City of Seattle

DESIRABLE LOCATIONS FOR UTILITIES (RESIDENTIAL STREET)

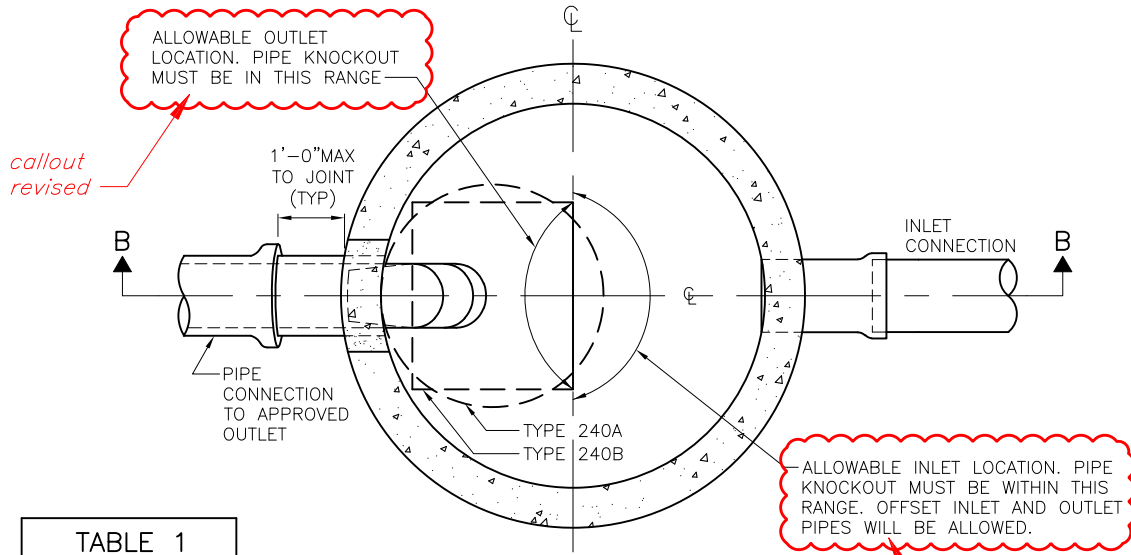
"PAVEMENT" changed to "ROADWAY"

callout revised FOR CLEARANCES, SEE DRAWINGS

FIRE HYDRANT MARKER LAYOUT

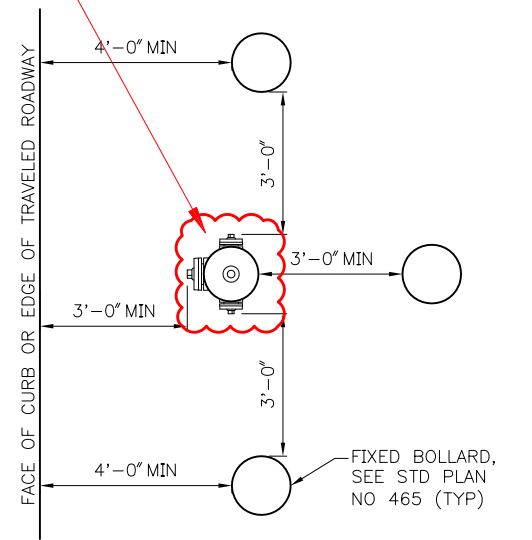
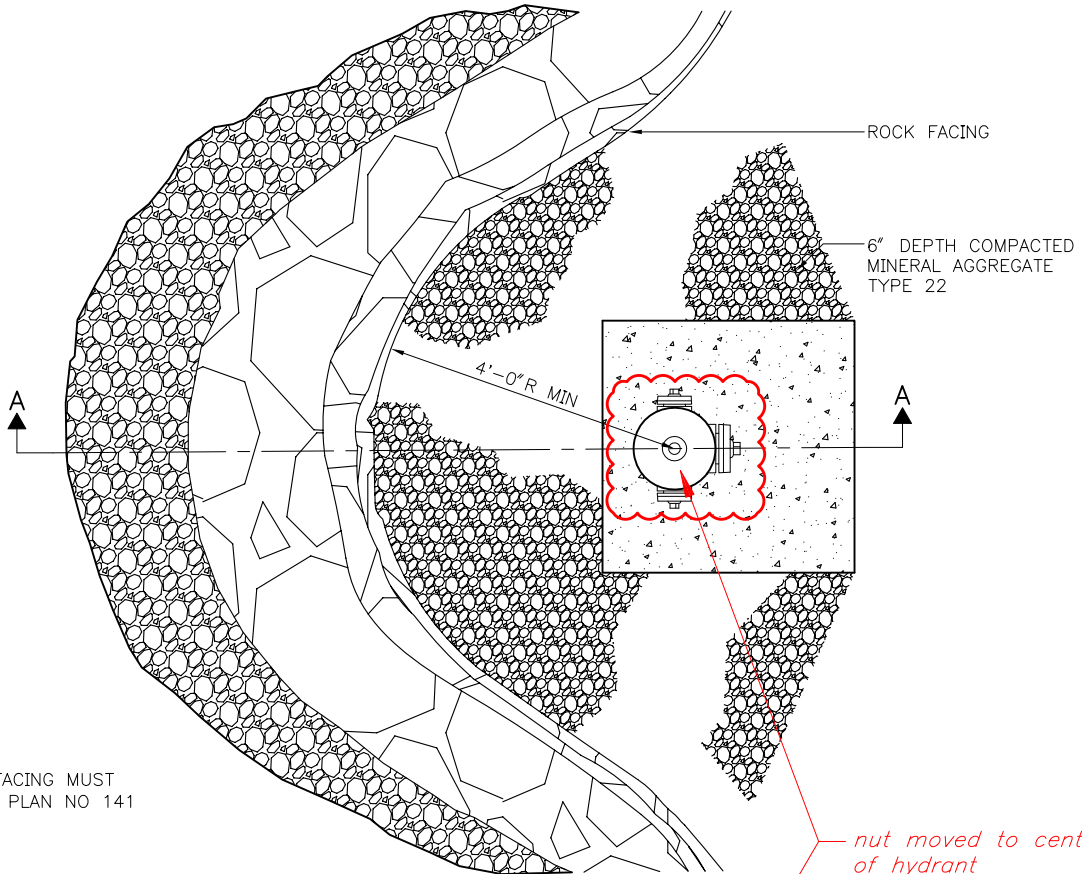
nut moved to center of hydrant

**FIRE HYDRANT
LOCATIONS & CLEARANCES**

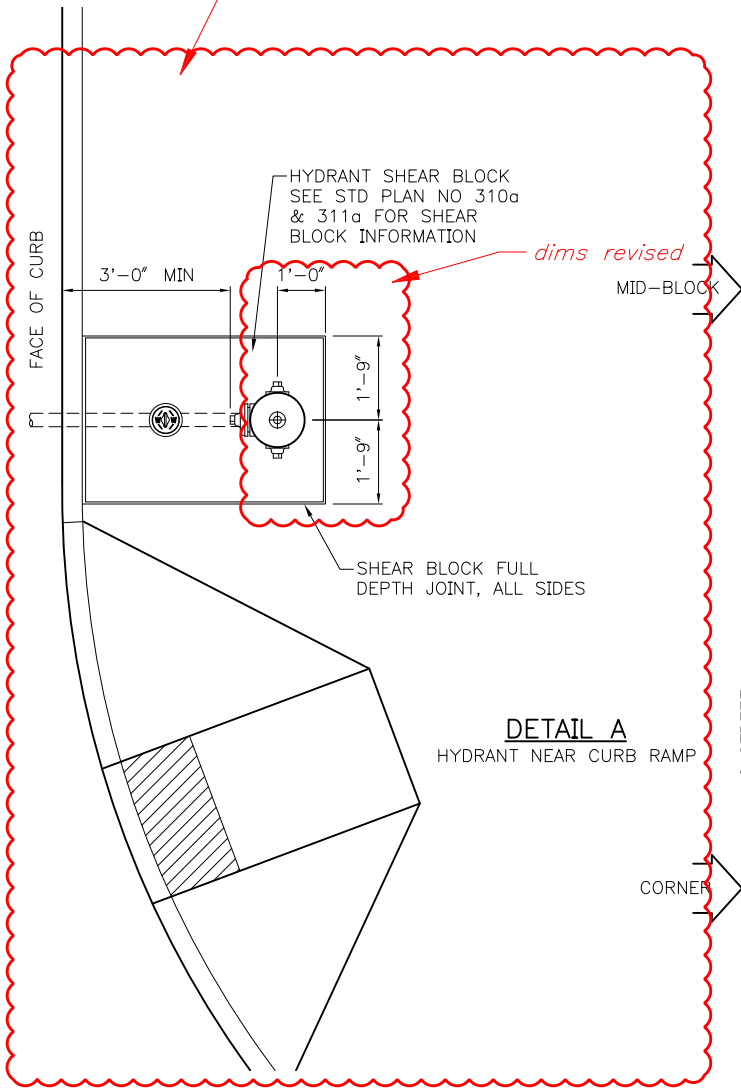
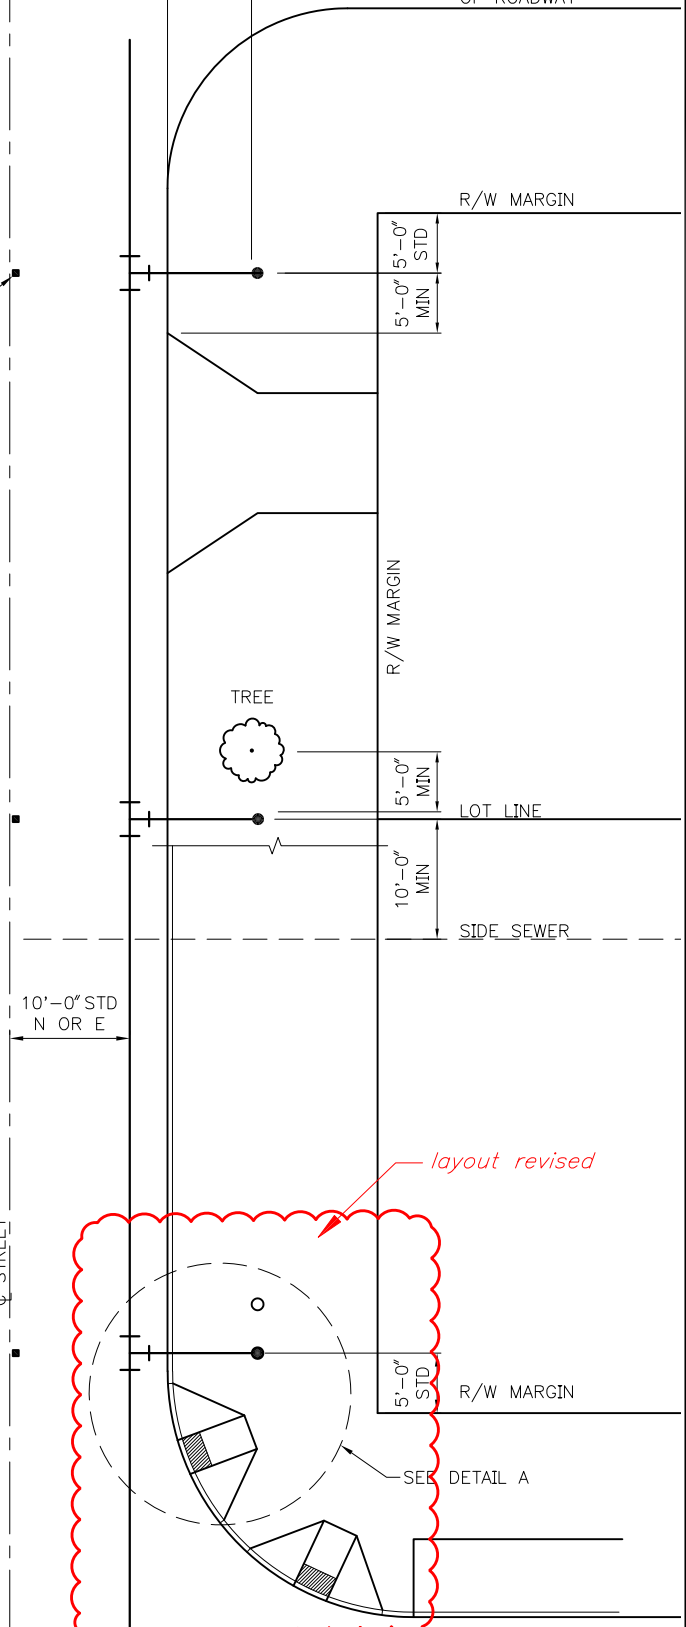
notes added/revise

detail revised

1. NO PARKING ZONE WITHIN 15'-0" RADIUS OF FIRE HYDRANT
2. MIN DISTANCE FROM CENTER OF HYDRANT TO FIXED OBJECT 4'.
3. MIN DISTANCE FROM HYDRANT PUMPER PORT TO CURB FACE/ROADWAY 3'
4. MIN DISTANCE FROM HYDRANT TO ANY PART OF CURB RAMP MUST BE 2'
5. BLUE LANE MARKER MUST BE 6" OFFSET FROM CENTER OF ROADWAY IF CENTERLINE IS NOT STRIPED, OR 6" OFF STRIPED CENTERLINE. WHERE MEDIANS OR TWO-WAY LEFT TURN LANES EXIST, MARKER MUST BE INSTALLED WITH 6" OFFSET FROM THE LANE LINE CLOSEST TO THE HYDRANT

CLEARANCES FOR TYPICAL WATER SERVICE VAULTS

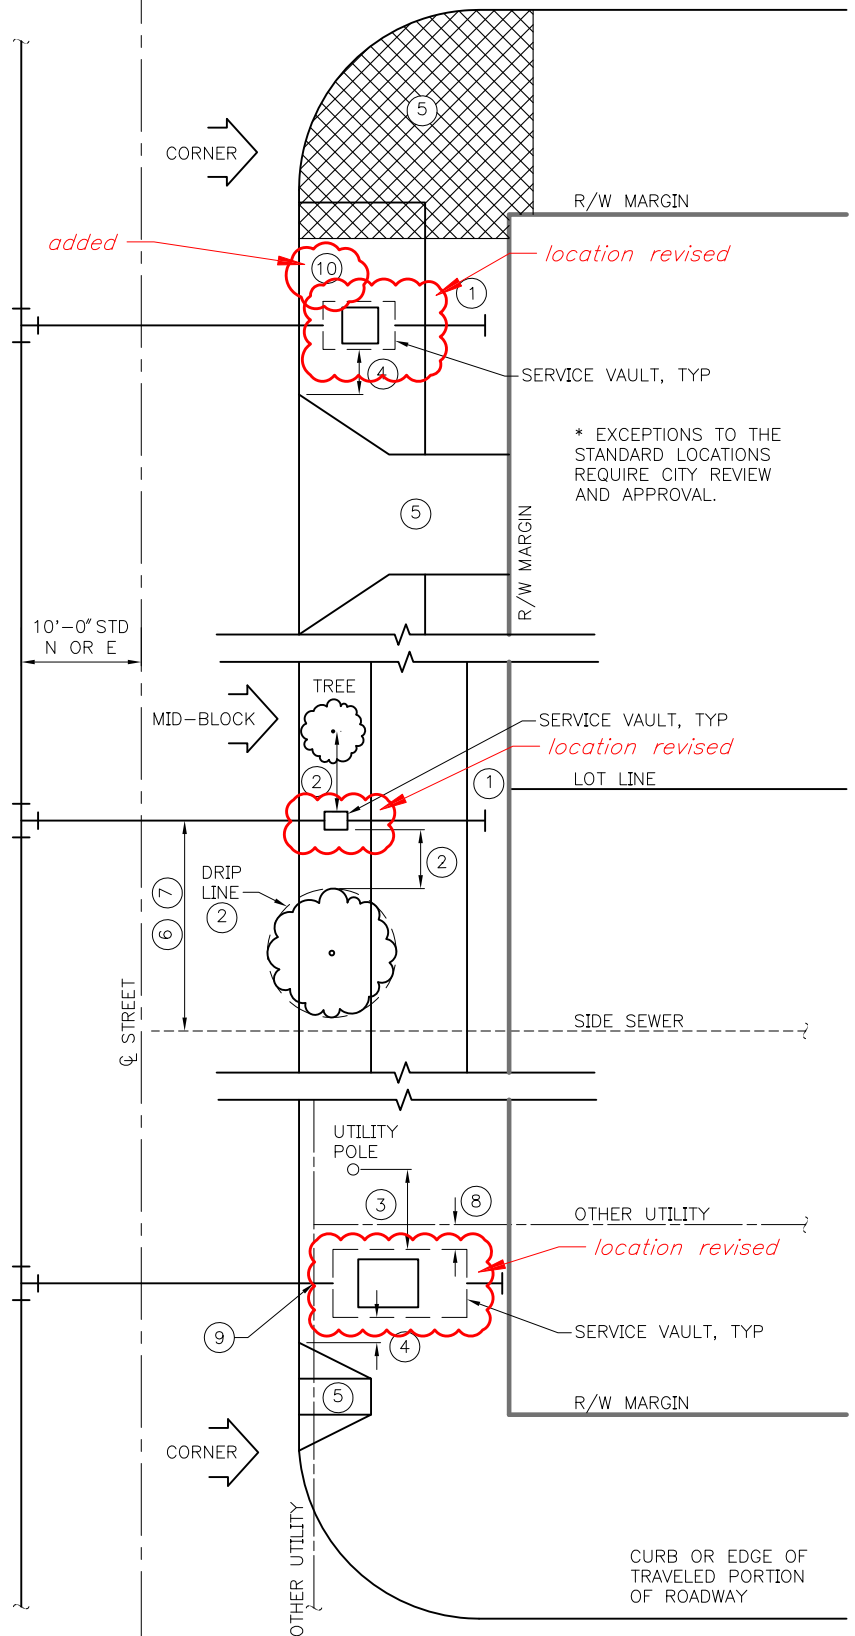
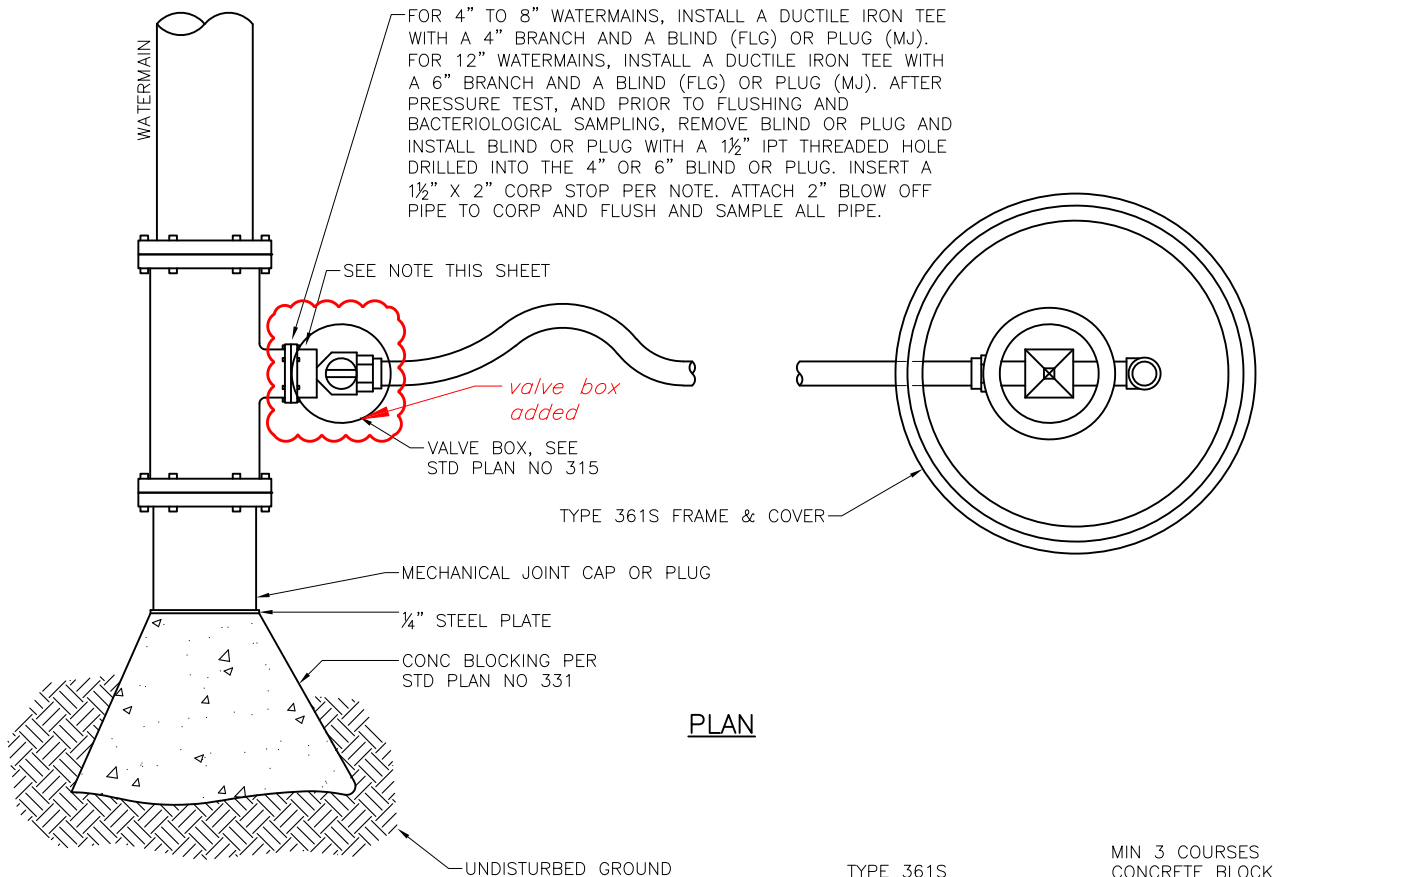
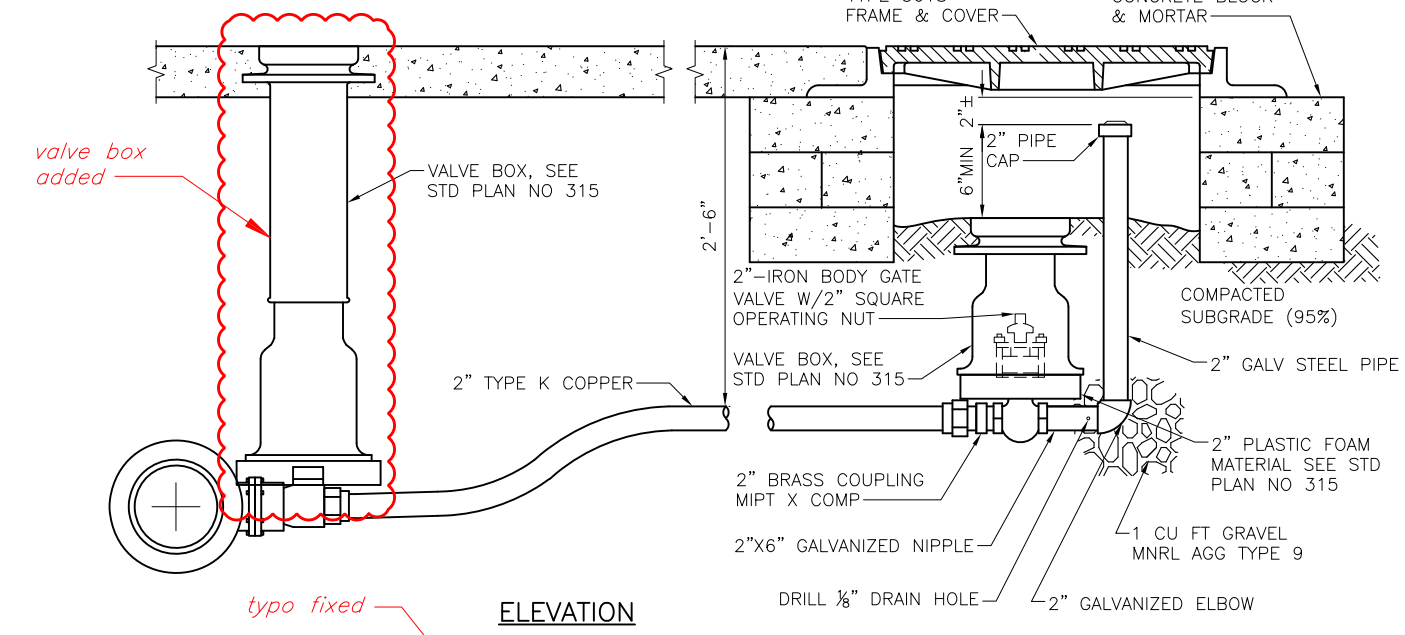
"OR" changed to "AND"

notes added

ROADWAY CONCRETE PAVEMENT
JOINTS

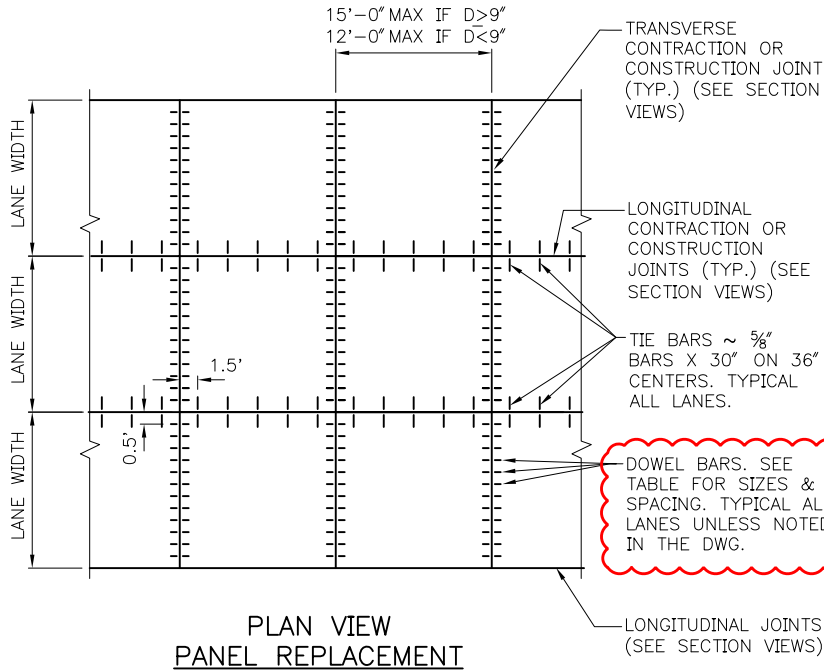
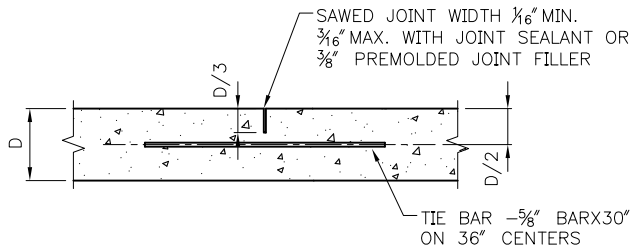
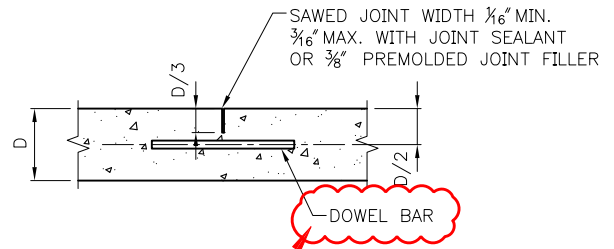
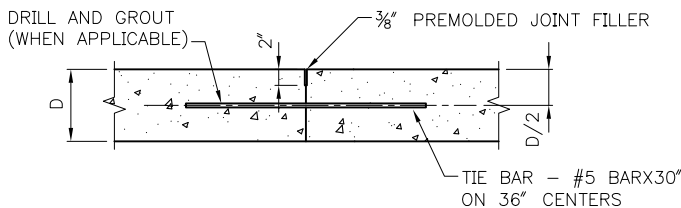
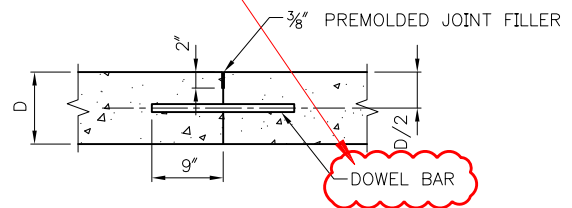
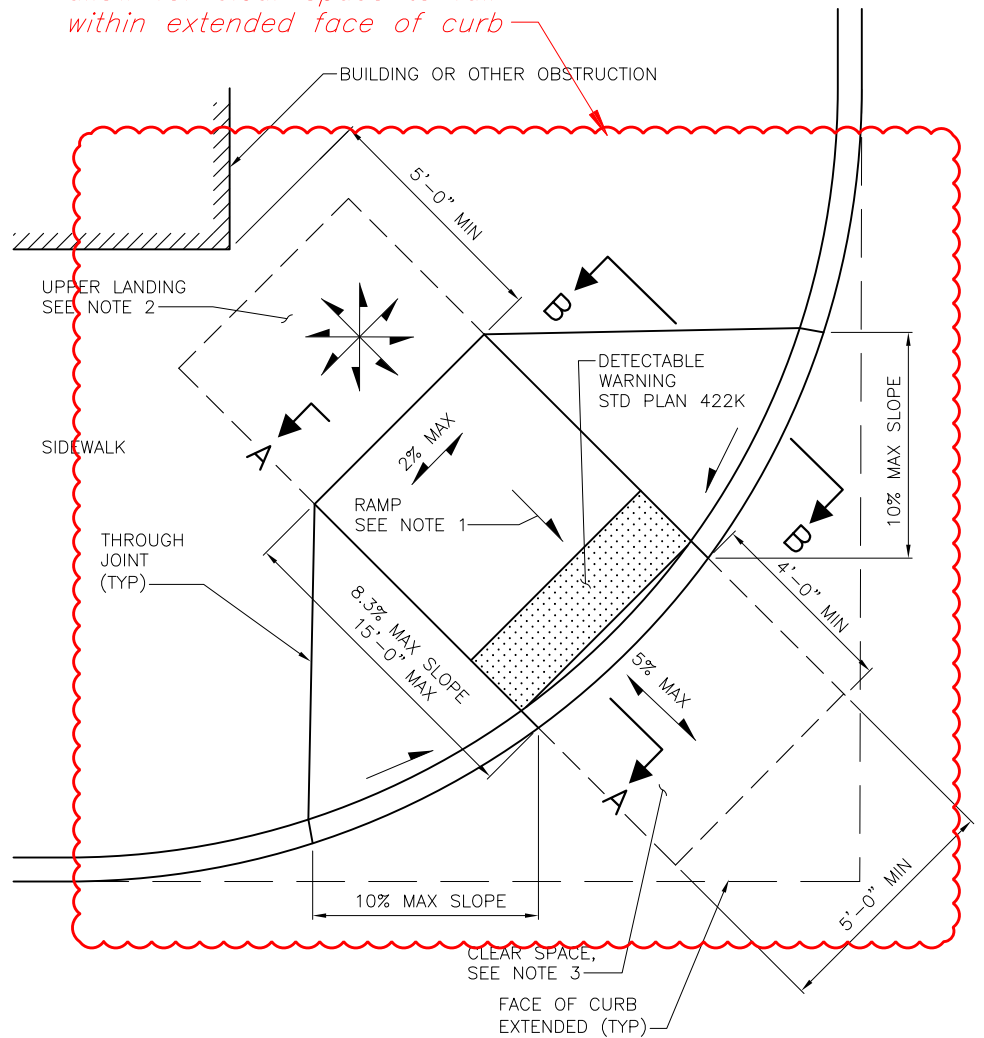
callout revised

table revised

callouts revised

DEPTH (D) OF RDWY CEM. CONC	SOLID STEEL DOWEL BAR SIZE OUTSIDE DIAMETER (OD) X LENGTH (L) @ ON CENTER (OC)	TUBULAR DOWEL BAR SIZE OUTSIDE DIAMETER (OD), WALL THICKNESS X LENGTH (L) @ ON CENTER (OC)
6" ≤ D < 9"	1.00" OD X 18" L @ 12" OC	1.375" OD, 0.120" MIN X 18" L @ 12" OC
9" ≤ D < 11"	1.25" OD X 18" L @ 12" OC	1.375" OD, 0.120" MIN X 18" L @ 12" OC
11" ≤ D	1.50" OD X 18" L @ 12" OC	1.625" OD, 0.120" MIN X 18" L @ 12" OC
